From: Vivianne Marston
Sent: 21/01/2025 4:51:15 PM
To: Council Northernbeaches Mailbox
Subject: TRIMMED: DA 2024/1562 submission for 5 Lauderdale Ave FAIRLIGHT
Attachments: 24060 Submission on 5 Lauderdale Avenue Fairlight 21Jan2025 + appendices for Council.pdf;

Address: 5 Lauderdale Avenue, FAIRLIGHT NSW 2094

Development Demolition works and construction of a residential flat building including strata subdivision

Application number DA2024/1562

Figure 2: Existing and proposed shadow impact of the development to the POS of 3B Lauderdale Avenue Fairlight

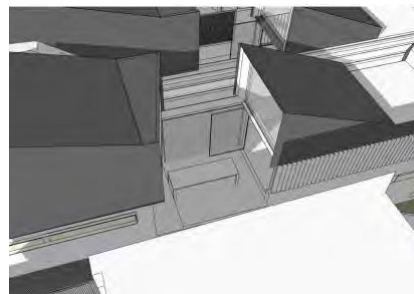
- (2) In response, new shadow diagrams have been prepared which accurately depict the adjacent development and the proposed development's impact on 3B Lauderdale Avenue (see **Figure 2**).

- (4) Given that the proposed Manly LEP 2013 and Manly DCP 2013 non-compliances cause this overshadowing, (see **Points A, B and C** above), the loss of solar access is unreasonable.

Recommendations 1, 2, and 3 would assist in addressing solar access concerns

Figure 3: Sightlines from the proposed RFB into the POS Ares of 3B Lauderdale Avenue

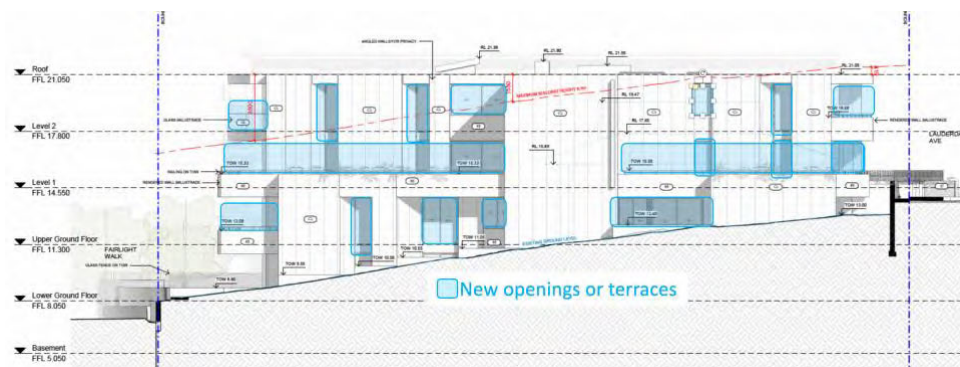
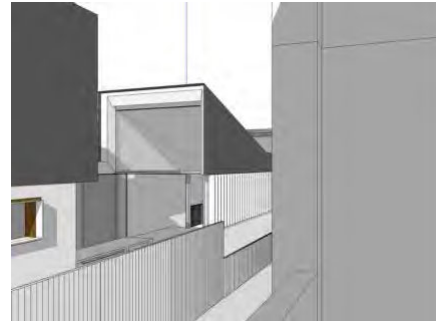
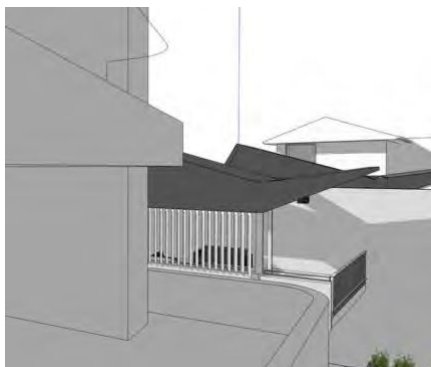
(1) The proposed East Elevation, facing 3B Lauderdale Avenue, includes numerous clear glass windows as well as elevated terraces to the front, side and rear setbacks at the Upper Ground Floor, Level 1 and Level 2, that will have a direct line of sight to POS and living rooms at 3B Lauderdale Avenue (see proposed images at **Figure 3**). This loss of amenity is unreasonable, given that the adverse impact arises from a development that that contravenes the following standards and controls:

- Manly LEP 2013 8.5m height standard and 0.6:1 FSR standard (see Point A and B above)
- Manly DCP 2013 Section 4. (see Point C above).

Recommendations 1, 2, and 3 would assist in addressing privacy concerns

Figure 27. Site Plan

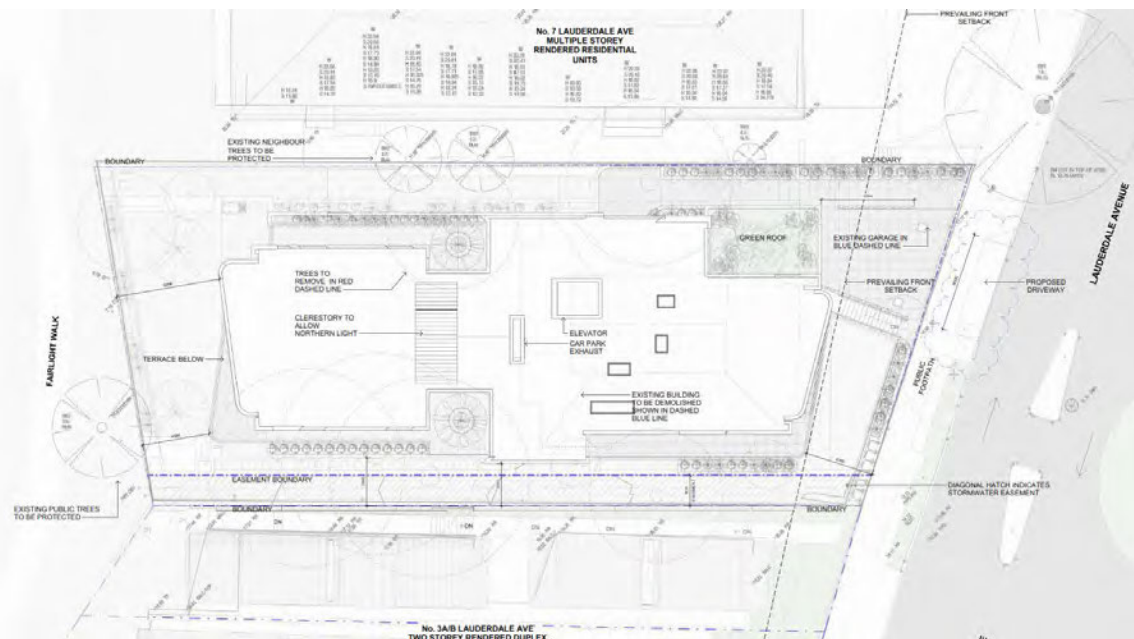
Poor site analysis has lead to poor design choices
DA0100	Site Plan	Inadequate dimensioning generally. Significant parts of the development (eg extent of roof on north/east corner) has no offset dimension to the boundary allowing the applicant to modify the extent of the built form at a future stage
		Failure to note RLs generally
		Crossing for pedestrians in safe zone not acknowledged (coloured green to indicate turf)
		Built structure (bin area) over an easement not permitted
		Depth of proposed bin area not noted - do bins fit or will they be a pedestrian & cycle hazard.
		Boundary screening on shared boundary with 3B indicated with a diagonal hatch which is unclear
		Planted areas in 3B incorrectly shown
		Building alignment of 3B incorrectly shown
		Trunk diameter of existing trees incorrectly shown and trees not numbered
		Tree protection zone and structural root zone of Trees 1 and 10 have not been shown

Figure 30. Section A
 Source: Platform Architects.

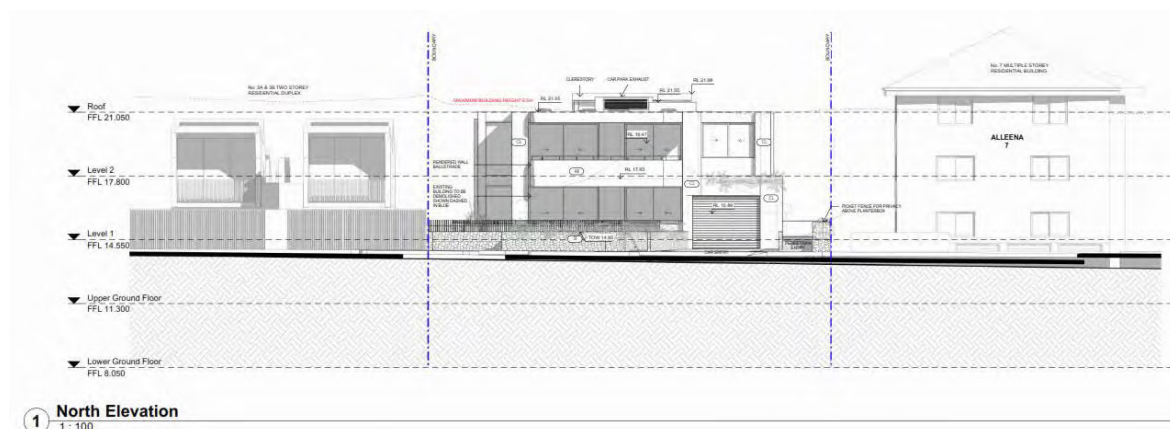
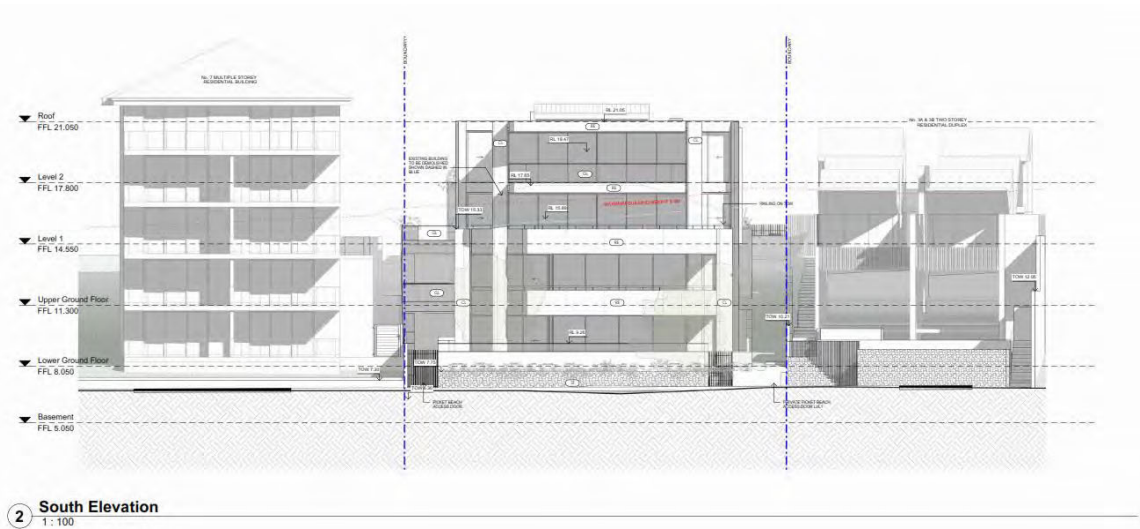
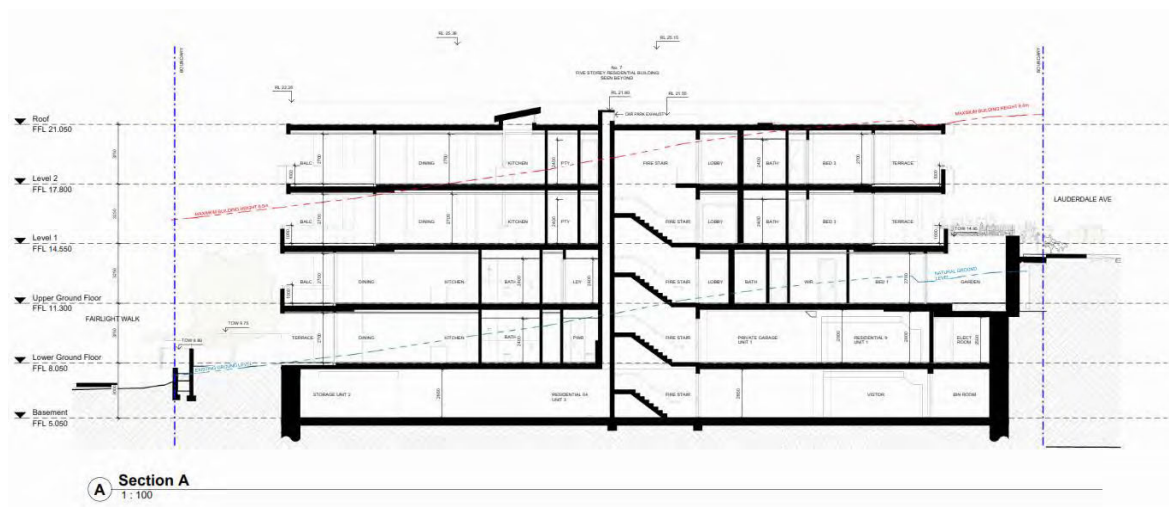
*Figure 31. Perspective showing the over development of the proposal.
Source: Platform Architects.*
